ASSESSMENT REPORT Angus Place Colliery Extension of Longwalls 980 and 900W (06_0021 MOD 3)

Figure 4: Proposed Longwall 980 Extension showing key surface features

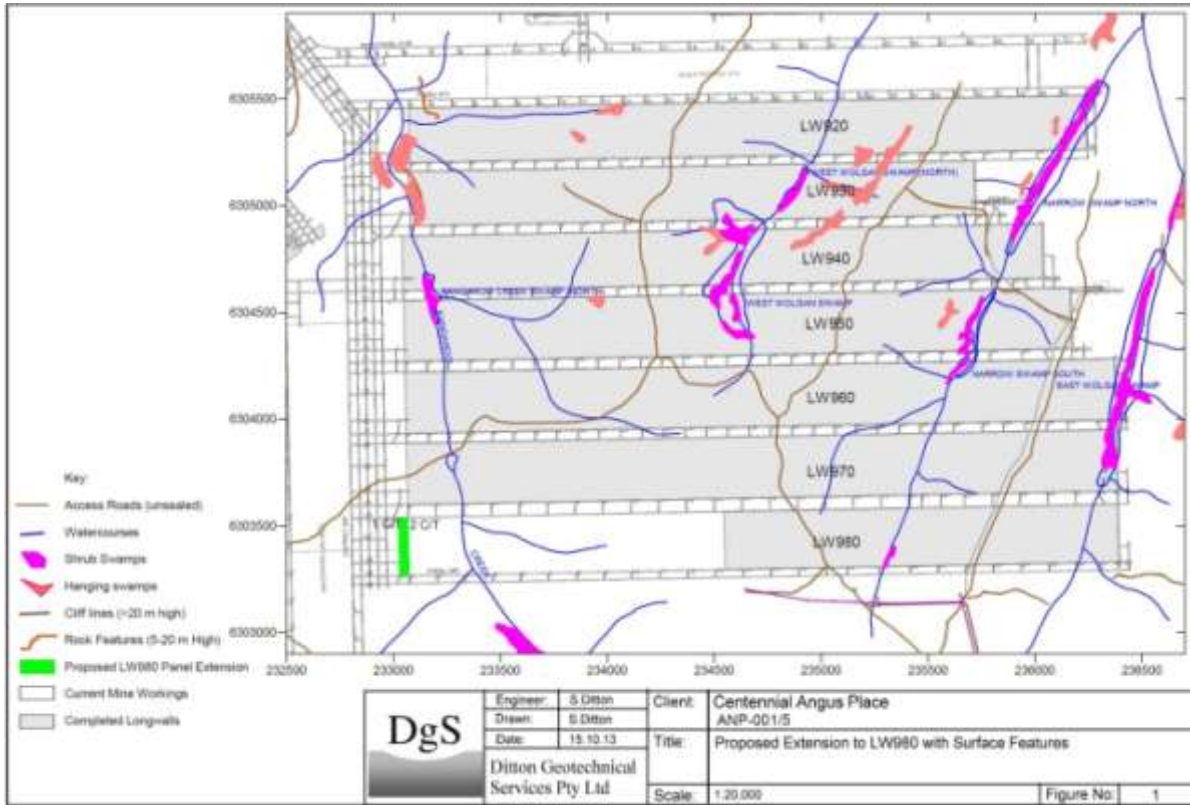
The area in which Longwall 980 is proposed to be extended by 43.4 m is located below the Newnes State Forest. The land above the area of the proposed extension is gently undulating with slopes of less than 10 degrees and is vegetated with native trees and shrubs. As shown on **Figure 4**, there are no sensitive features (cliff lines, rock features, watercourses, access roads, Aboriginal Heritage Sites, or endangered ecological communities (EECs) listed under the *Threatened Species Conservation Act 1995 (TSC Act)*) on, or near, the land above the proposed extension area.

Tables 1 and 2 show that the increased mining height results in only very minor changes to the predicted subsidence, tilt, tensile strain and compressive strain, with the vertical subsidence as a result of the increased height being in the order of 40-50 mm.

DgS modelled the net maximum subsidence that could occur as a result of the 43.4 m extension of Longwall 980 in conjunction with the increase in mining height from 3.25 m to 3.425 m. The model showed an increase of 50 mm of subsidence between 10CT and 2CT with the subsidence contours moving a distance of approximately 43 m to the west, in response to the extended panel length.

The observed subsidence effects following the extraction of these longwalls (as shown on **Figure 5**) are in line with these predictions. Based on the minor nature of predicted increases, the Department considers the impacts associated with the extension of Longwall 980 by 43 m and increasing its extraction height to 3.425 m are acceptable and would remain within the range of environmental consequences already approved, albeit extending into a slightly larger area.

Figure 6: Proposed Longwall 900W Extension showing the surface features in the area

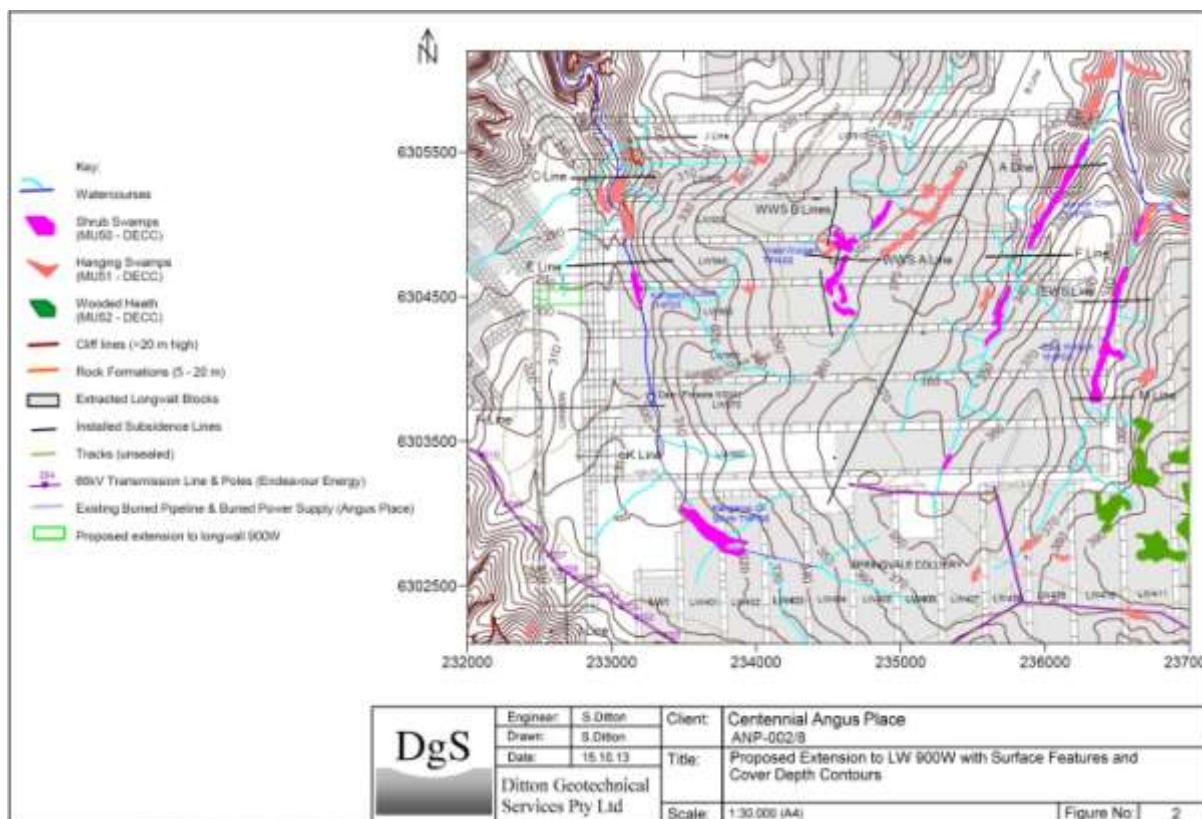
The area in which Longwall 900W is proposed to be extended is also located beneath the Newnes State Forest. The land surface in this area is gently undulating with slopes of generally less than 10 degrees and is vegetated with native trees and shrubs.

Longwall 900W has been approved with a void width of 293 m and a length of 2087 m. Centennial proposes to undertake extraction of Longwall 900W at a maximum mining height of 3.425 m. As shown on **Figure 5**, there are no sensitive natural features (cliff lines, rock features, Aboriginal Heritage Sites, access roads or EECs listed under the TSC Act) in the area above the proposed extension area. There is, however, one first order tributary of Kangaroo Creek in this area.

DgS modelled the net maximum subsidence resulting from a 104.8 m extension of Longwall 900W and an increase in mining height from 3.25 m to 3.425 m. The model showed an increase of 60 mm to 80 mm in maximum subsidence between 20CT and 3CT. The model also shows that the subsidence contours would extend approximately 100 m to the north, in response to the extended panel length.

Based on the minor nature of the predicted increases to the subsidence effects and the subsidence impacts observed to date above Longwalls 920 – 970, the Department considers that the environmental impacts of the proposed extension to Longwall 900W are acceptable and would remain within the predicted range of environmental consequences already approved, albeit extending a slightly larger area.
